STERLING RANCH EAST FILING NO. 5

CONSTRUCTION DRAWINGS

OCTOBER 2024

STRELING RANCH EAST FILING NO. 5
CONSTRUCTION PLANS
PUBLIC STORM SEWER PLAN

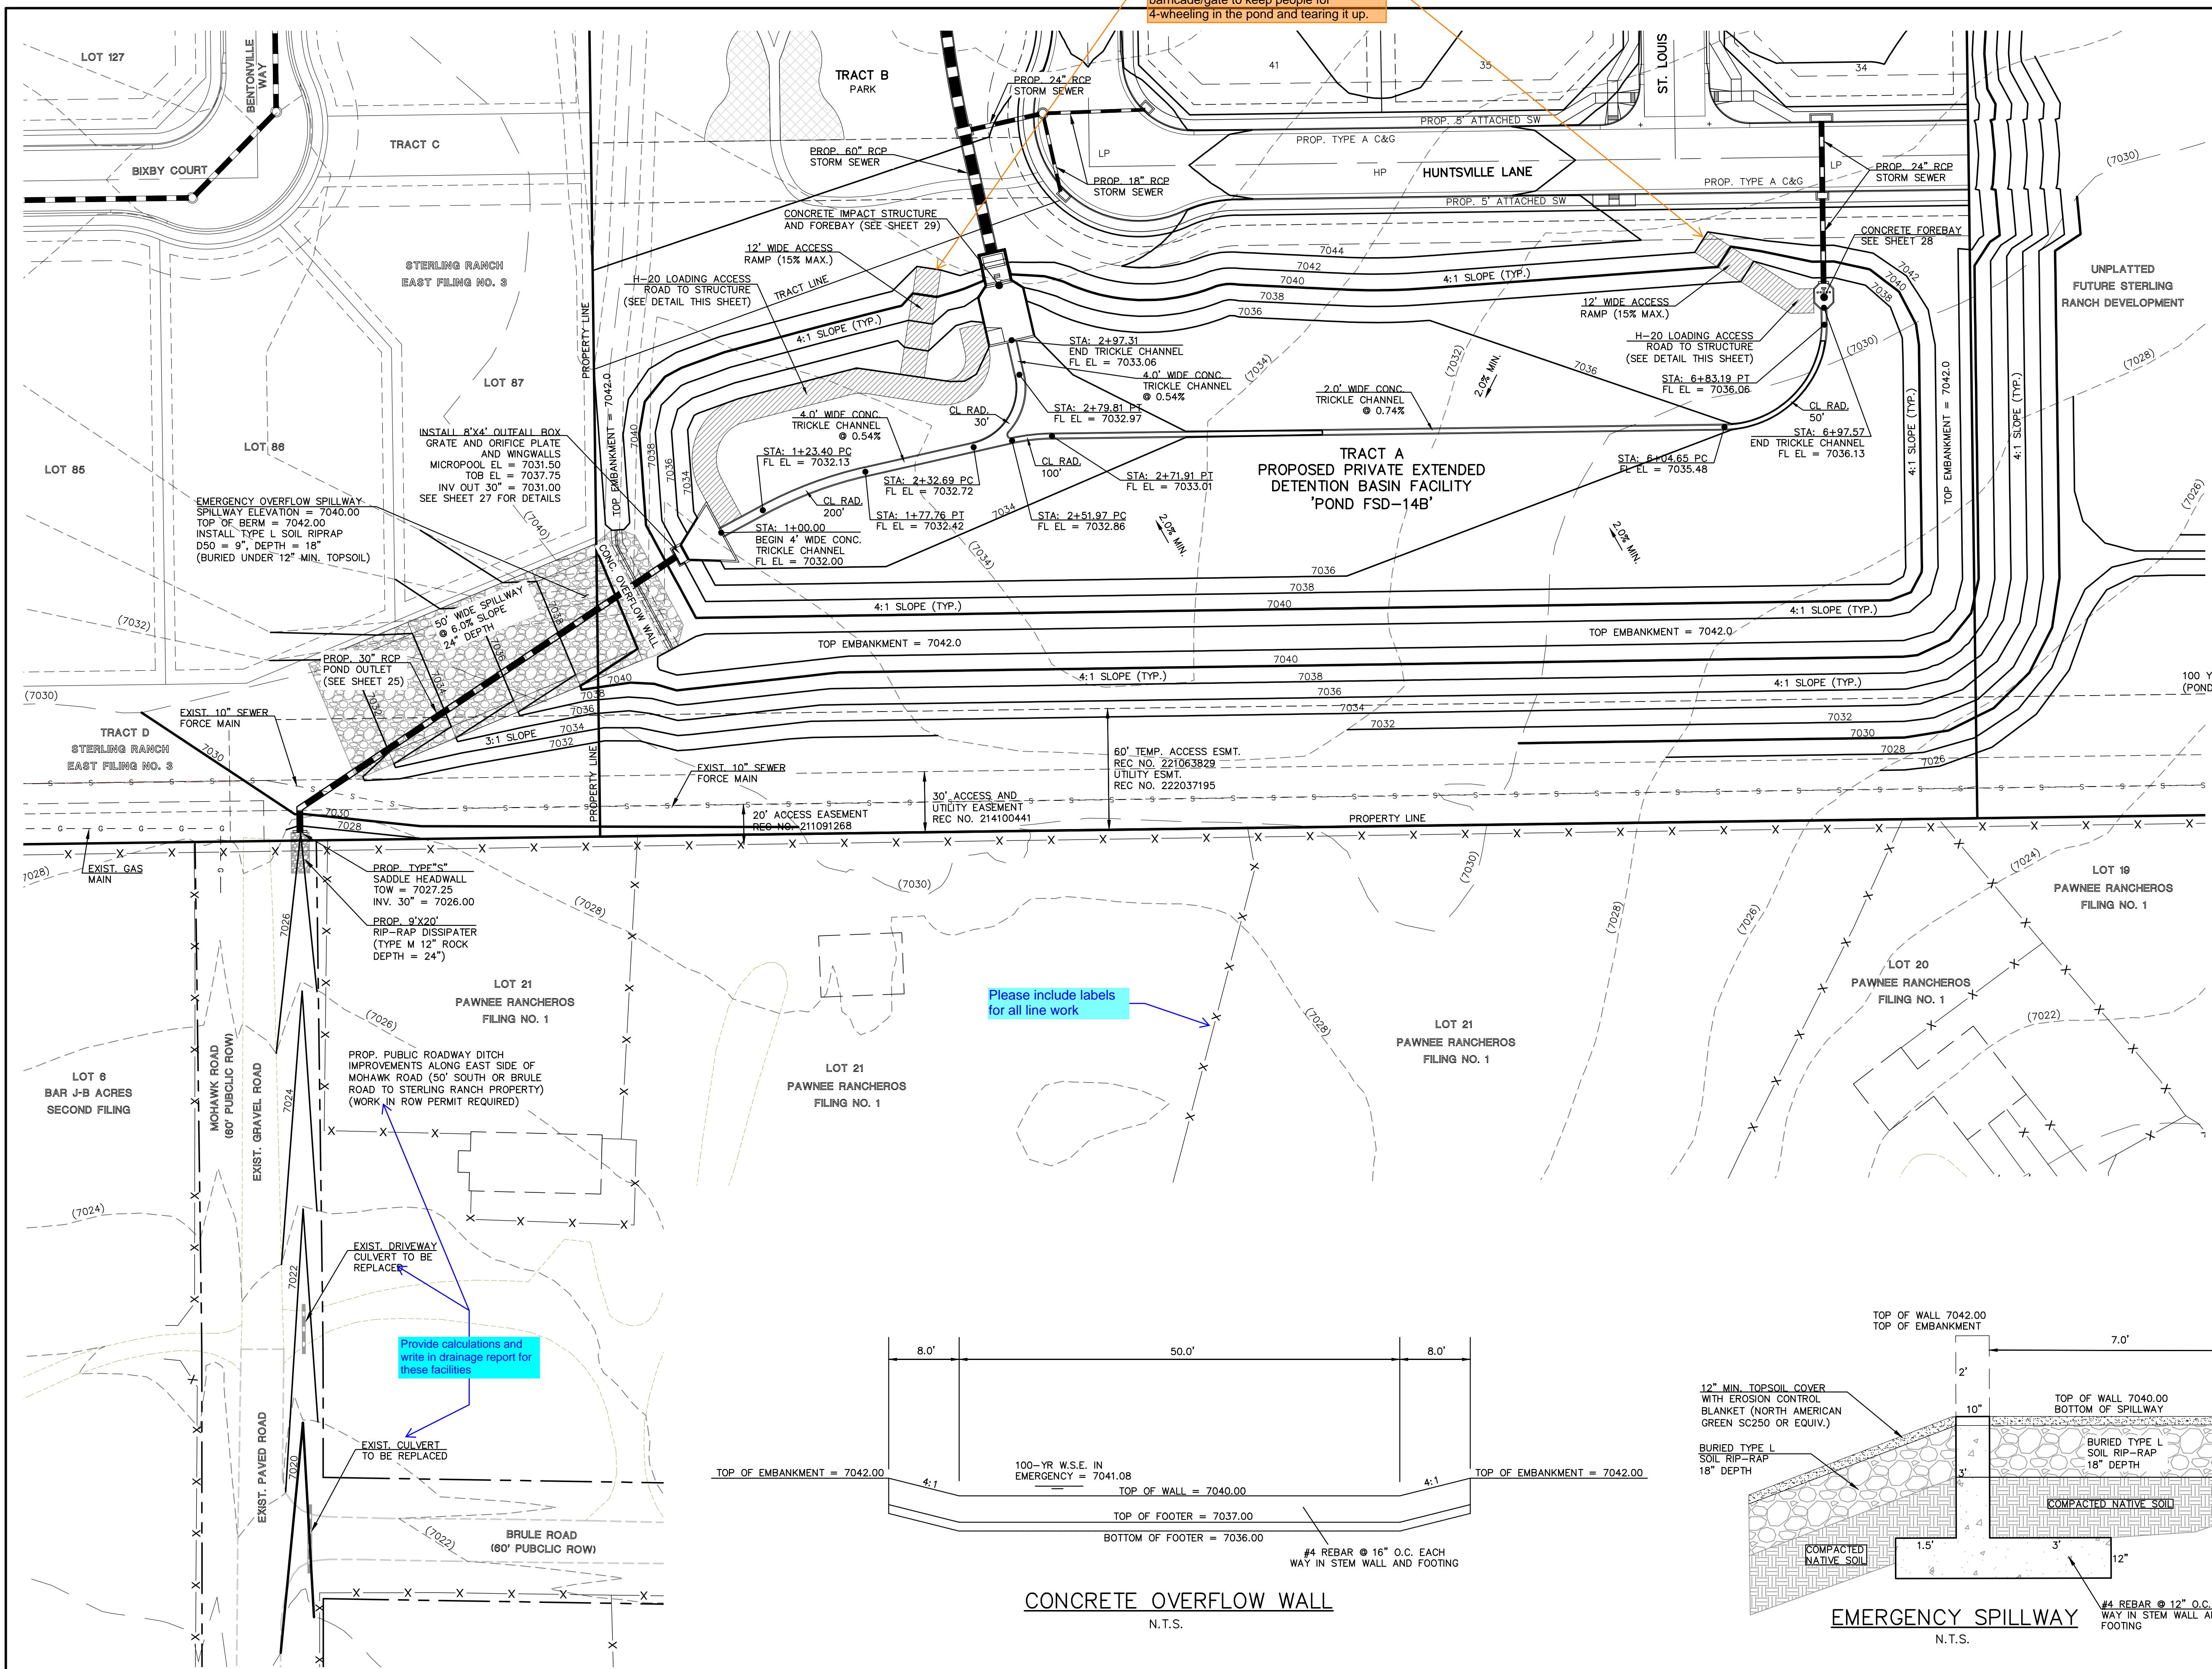
Please include a note for All storm sewer with 100-YR HGL above the top of the pipe shall be installed with pressure pipe and watertight joints with 100 year service life

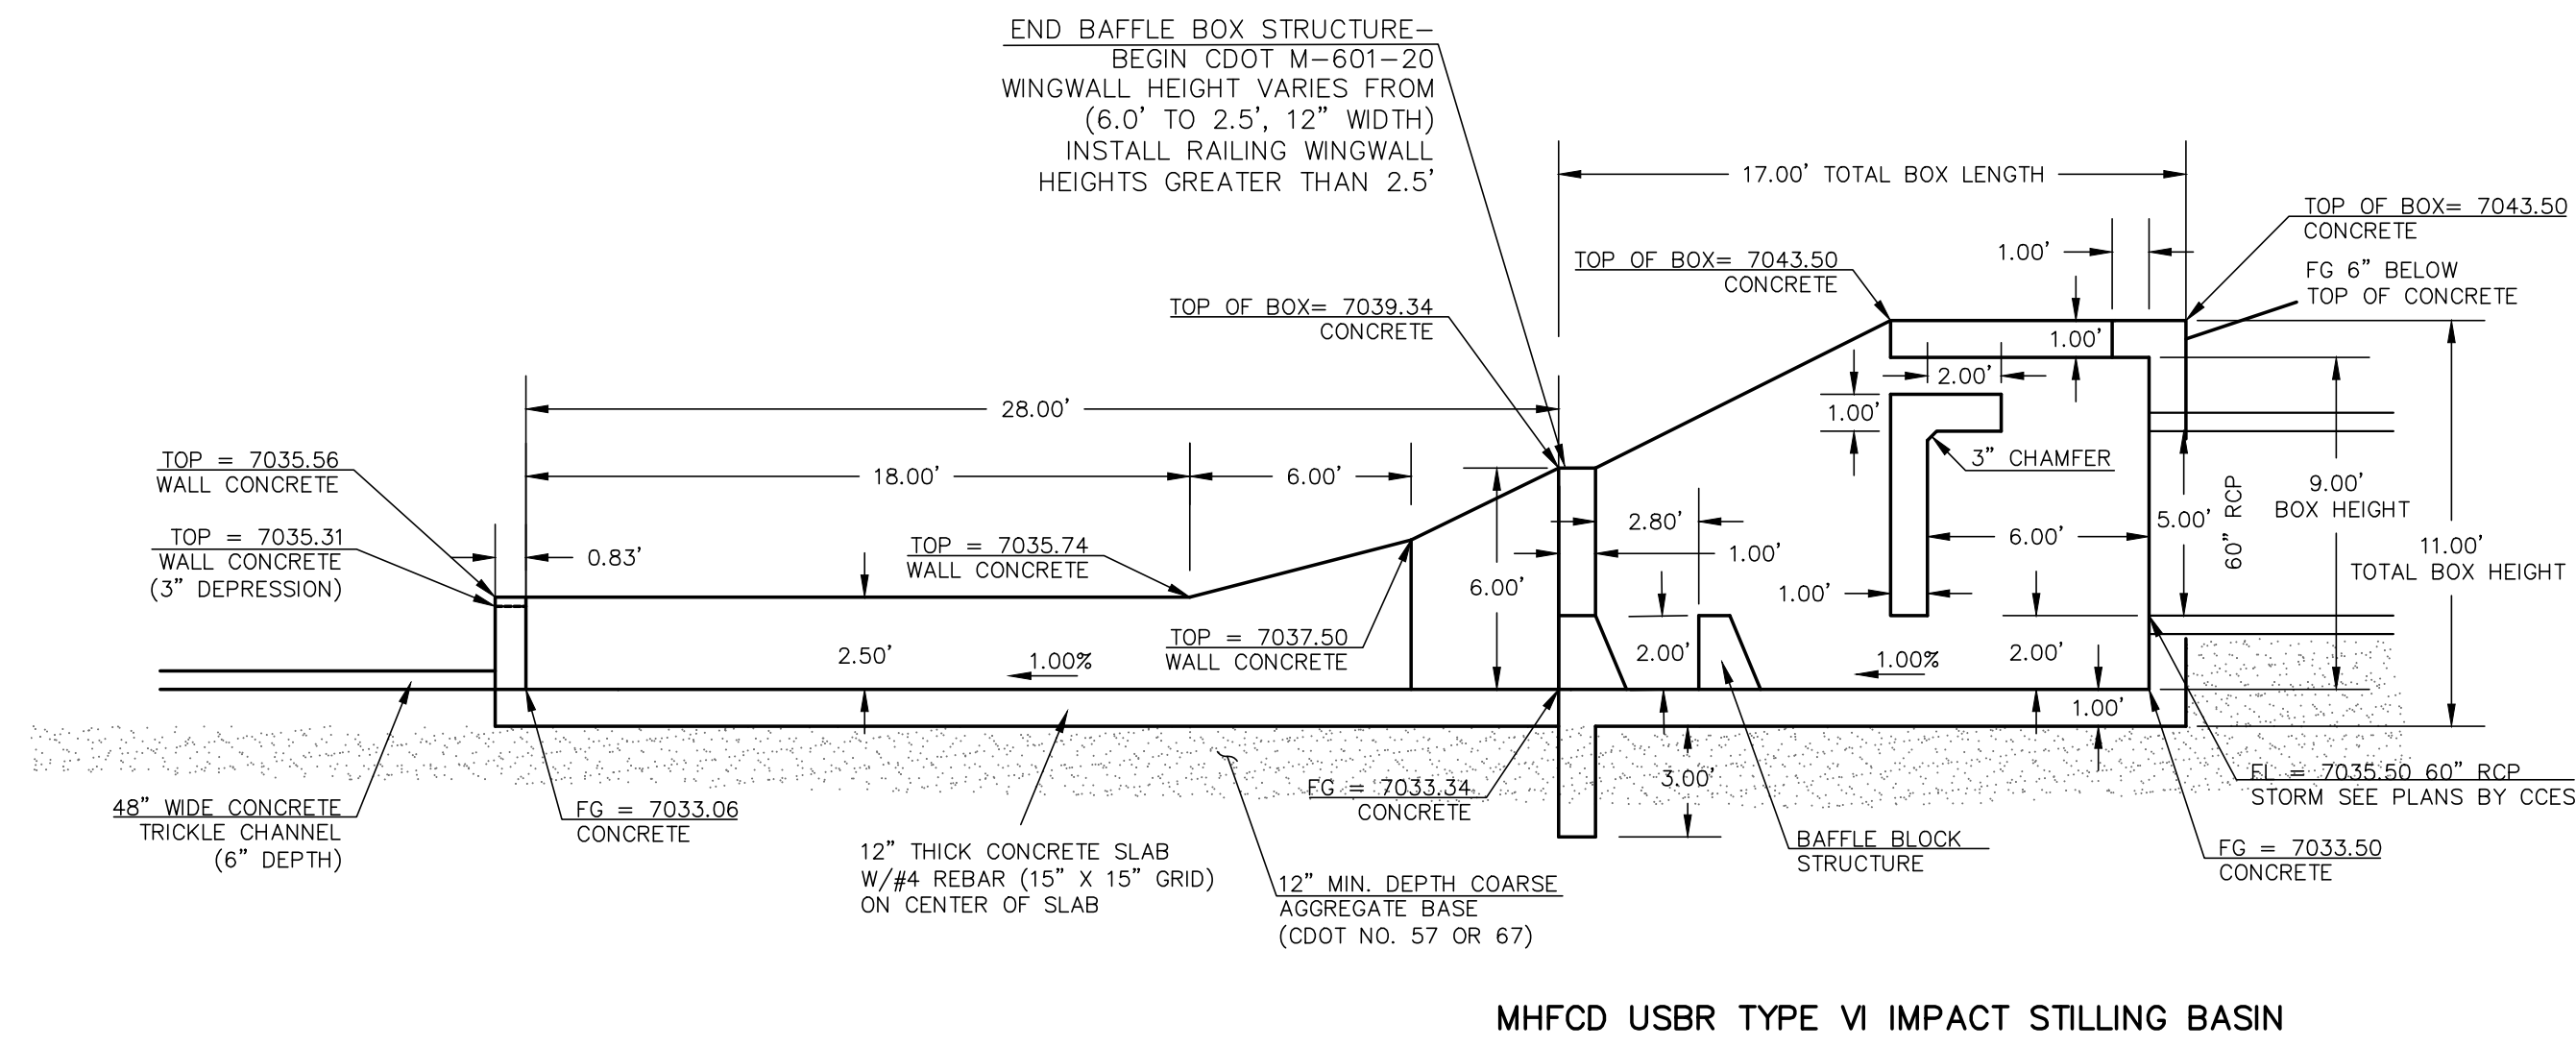
EPC SW recommends the following based on field observations of ponds over the years:
Soil riprap should also be provided on the downstream side of the forebay berm or wall if the downstream grade is lower than the top of the berm or wall. The forebay will overtop frequently so this protection is necessary for erosion control. All soil riprap in the area of the forebay should be seeded and erosion control fabric should be placed to retain the seed in this high flow area. (MHFD T-5)

PROPOSED FOREBAY AT 60" PIPE - POND STRUCTURE (PLAN VIEW)

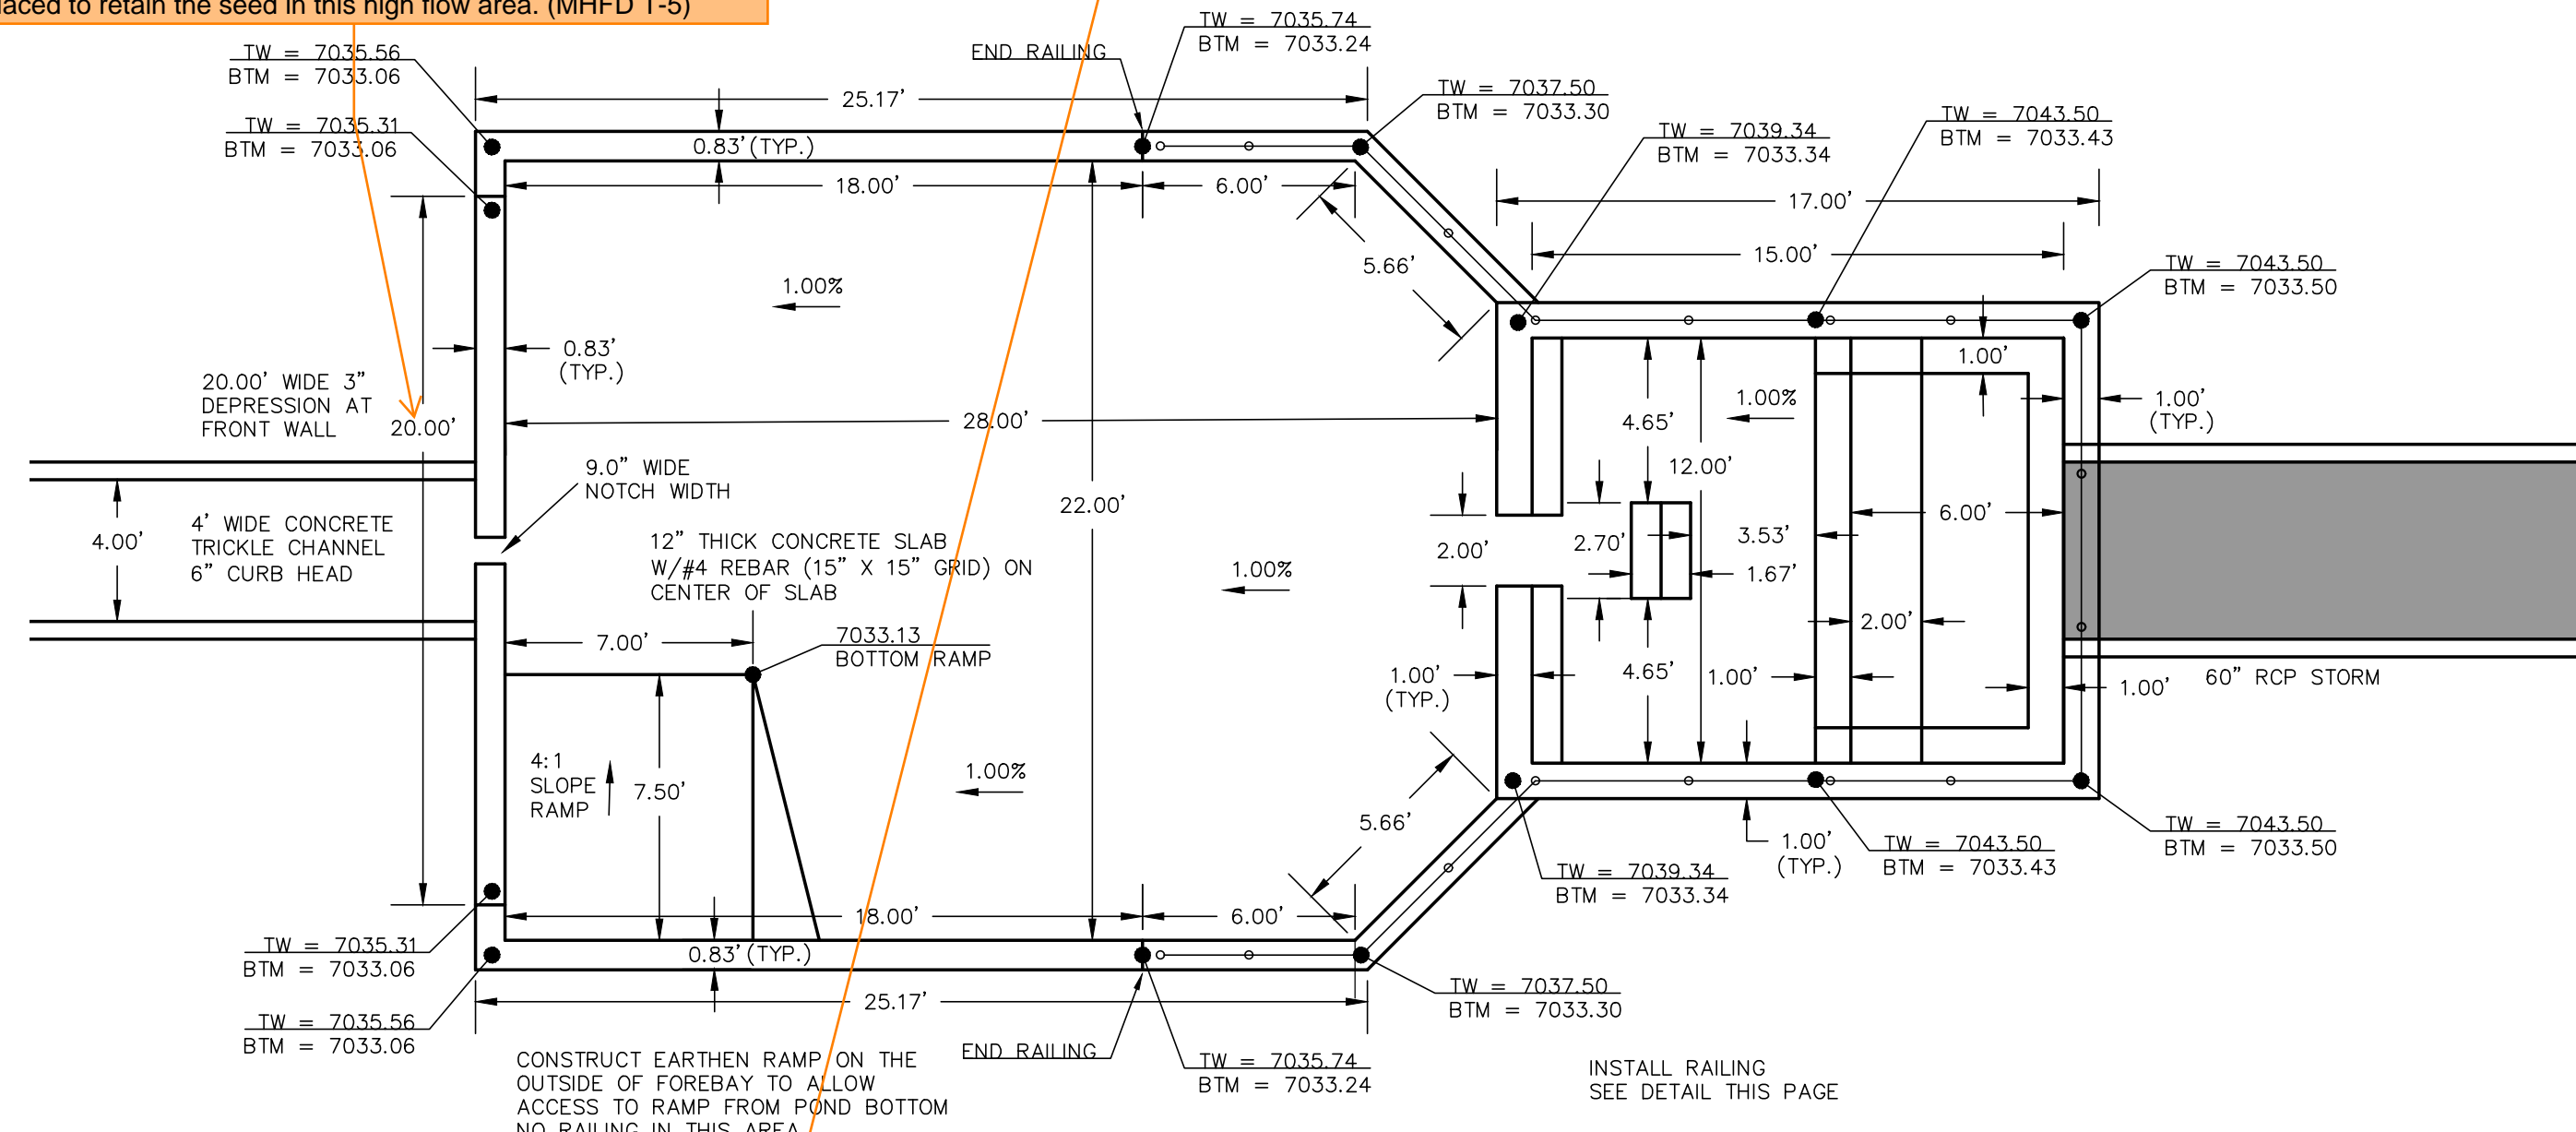
clarify that this is the "westerly" forebay to be consistent with plans above and FDR.
